YAMAHA MEASURE REPORT

REF. No. MC-88049

MODEL	TDR240/250, TZR250	FILE	
SUBJECT	PISTON MELTING AT CROWN

MODEL	TZR250 '87, '88	FILE	
SUBJECT	PISTON SEIZURE

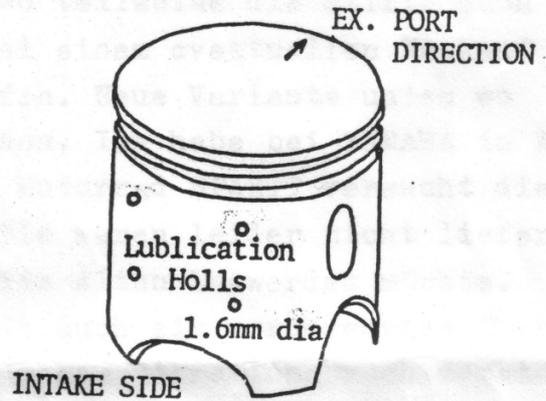
Market report indicate knocking engine noise and piston seizure.

At the early breake-in of an units, some units may be experienced scuffing between piston and cylinder wall insurficiant lubrication. Then scuffing caused to piston seizure.

To prevent scuffing at early breake-in, we are going to change the piston design as similure with 2YK type (TDR250) as a next model. The 2YK type piston has four location of lubrication holls at intake side as shoun in the left. These holls will provide greater lubrication effect between piston and cylinder wall comparison with present ones.

If you encounter a smilure problem, please recommend your dealer to use following part instead of STD ones. Recommended piston is as same as TDR250 model's one.

YZ TYPE LOCATING PIN

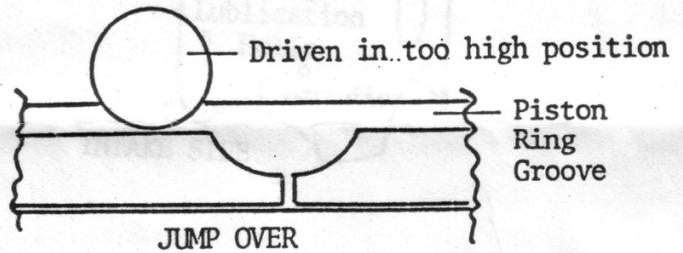
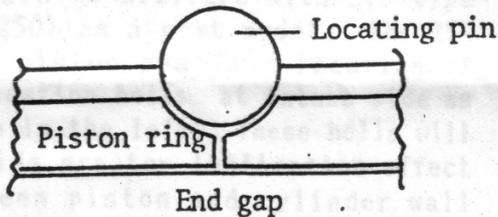
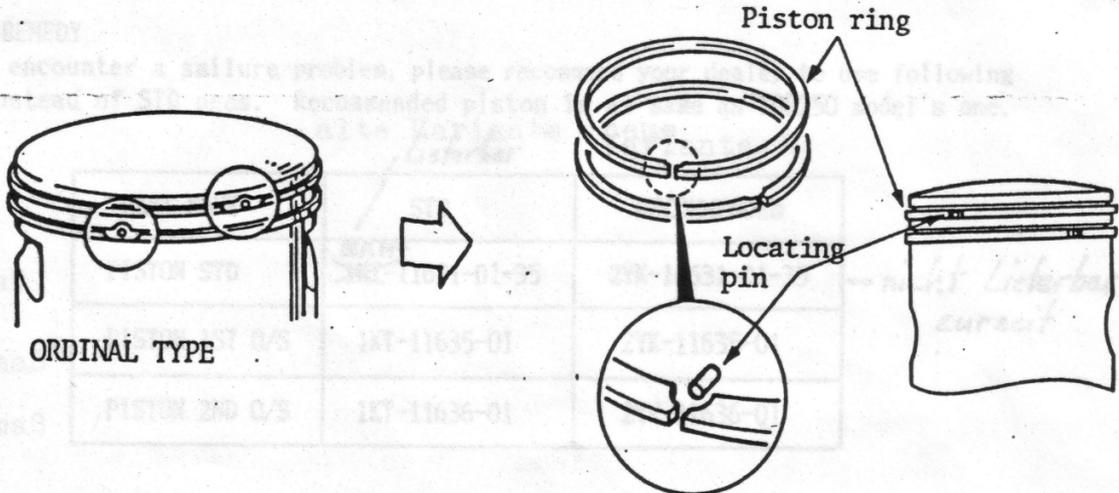
Market report indicates that the a piston ring is broken catching with cylinder port.

The piston ring located pin may be experienced driving into piston ring groove with insufficient dimension accuracy in some units (drivig upward comparison with specified location) . And also locating pin can be worn. These matter may cause that piston ring end gap can jump over the locating pin and then end gap will catch with cylinder ports. See below.

To prevent jumping over, locating method of piston ring will be changed to YZ type as shown in below. Now we are investigating this remedy to employ with next model.
